UNITED STATES PATENT AND TRADEMARK OFFICE

APPLICATION NO.	FILING DATE	FIRST NAMED INVENTOR	ATTORNEY DOCKET NO.	CONFIRMATION NO.
10/648,464	08/25/2003	James D. Ralph	F-286	8288
51640	7590	06/05/2007		
SPINE MP LERNER, DAVID, et al. 600 SOUTH AVENUE WEST WESTFIELD, NJ 07090			EXAMINER BLANCO, JAVIER G	
			ART UNIT 3738	PAPER NUMBER
			MAIL DATE 06/05/2007	DELIVERY MODE PAPER

Office Action Summary

DETAILED ACTION

Figure 5 of Xavier et al. '121 is shown below:

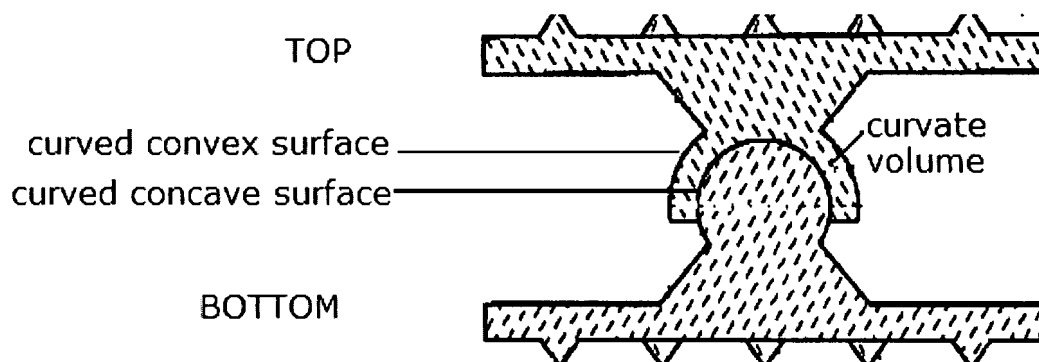
3. Claims 13, 16, 18, 20, 21, and 23 are rejected under 35 U.S.C. 102(b) as being clearly anticipated by Xavier et al. (US 6,063,121 A).
4. As seen in Figures 1-5, Xavier et al. disclose an intervertebral spacer device (10) comprising first (20) and second (48) plate members, each having an external plate surface thereof, wherein an inner surface of one of said plate members comprises a ball-shaped structure (ball supporting member 42 + ball 46, or ball 46 by itself) extending therefrom and an inner surface of the other one of said plate members has a spring (**first interpretation:** socket supporting member 62 and socket 68; **second interpretation:** cushion 80; **third interpretation:** socket supporting member 62 + socket 68 + cushion 80; **fourth interpretation:** socket 68 by itself) affixed thereto, said spring having an opening/curvate volume (**first interpretation:**

socket 68; **second interpretation:** central aperture 90; **third interpretation:** socket 68 + central aperture 90). Xavier et al. disclose socket supporting member 62, socket 68, ball supporting member 42, and ball 46 as made from either metal or ceramic (see column 4, lines 50-64), and able to counteract the load applied to at least one of the plate members (see column 4, lines 11-20). The spring/socket having a top side with a curved convex surface that extends from the curvate volume and confronts (i.e., face) the one of said plates and an underside with a curved concave surface that extends from the curvate volume and is spaced from and confronts (i.e., face) the other one of said plates.

The Applicants argue that Xavier et al. '121 do not disclose newly added limitation: "said spring/socket having a top side with a curved convex surface that extends from the curvate volume and confronts the one of said plates and an underside with a curved concave surface that extends from the curvate volume and is spaced from and confronts the other one of said plates". The Examiner respectfully disagrees. See representation of Figure 5 of Xavier et al. '121 above. It should be noted the language is not specific as to which plates each of the "curved convex surface" and the "curved concave surface" is respectively facing.
